ADDENDUM NO. 2
TO THE BID DOCUMENTS
Main Street Sidewalk Improvement
CITY OF HOMER, ALASKA

Addendum Issue Date: April 27, 2022

Issued By: Janette Keiser, PE
Public Works Director
City of Homer

**SINGLE PUMPER "L" BASE
HYDRANT ASSEMBLY**

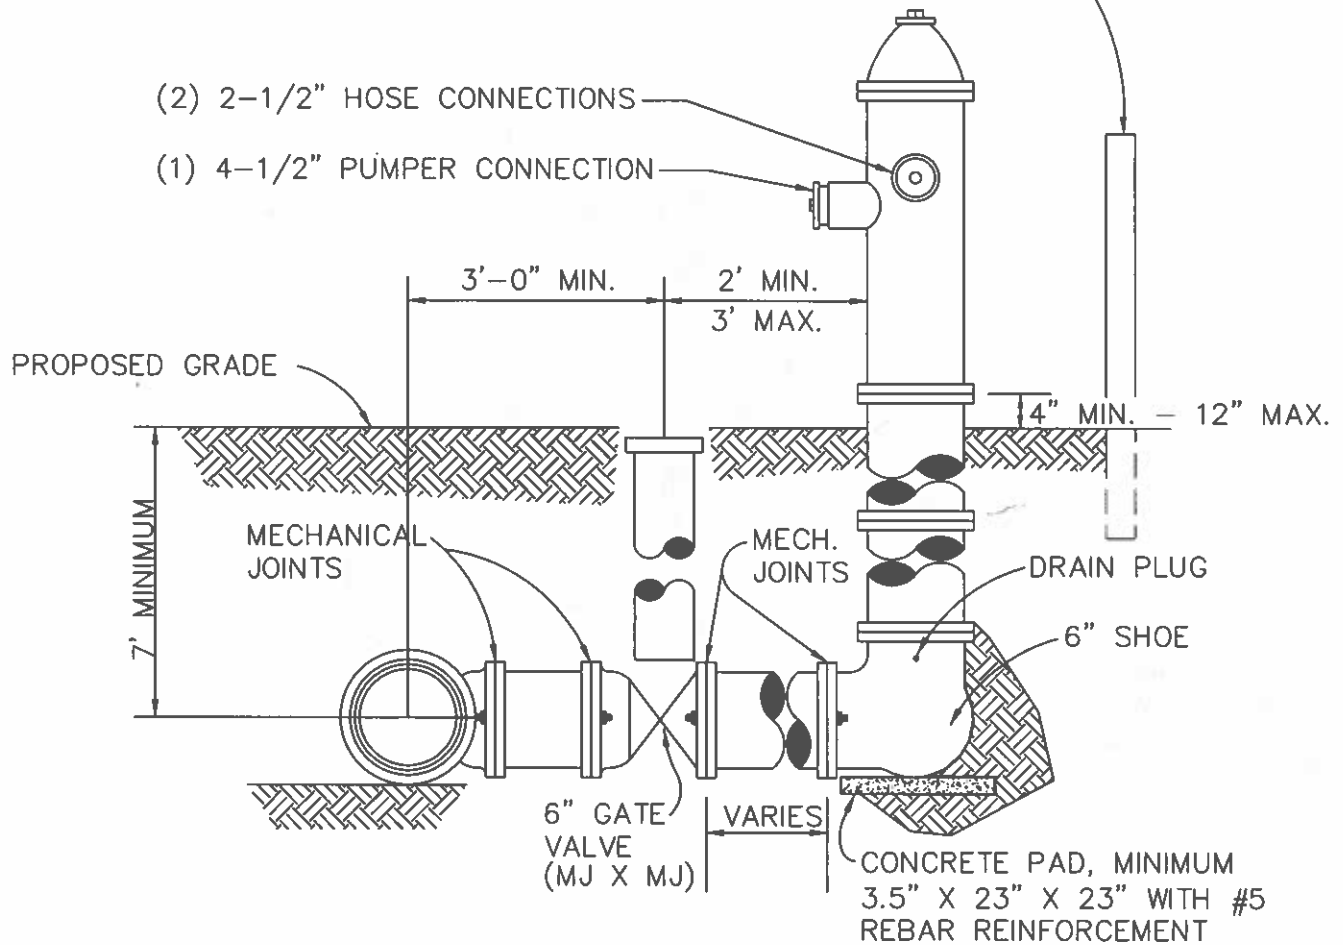
1. **Concern:** The plans do not have a detail attached for “Adjust Fire Hydrants”. This is a problem because they do not know what height the risers should be.

Response: The City of Homer Standard detail 600.04 is attached to this addendum for reference. The table below shows the height adjustments that will need to be made to the fire hydrants. Be aware that these adjustments are **approximations only** and that actual on-site conditions may require these adjustments to vary.

Station	Approximate Height Adjustment
16+53.55	+1.5 ft.
20+49.08	+1.0 ft.
36+27.47	+1.0 ft.
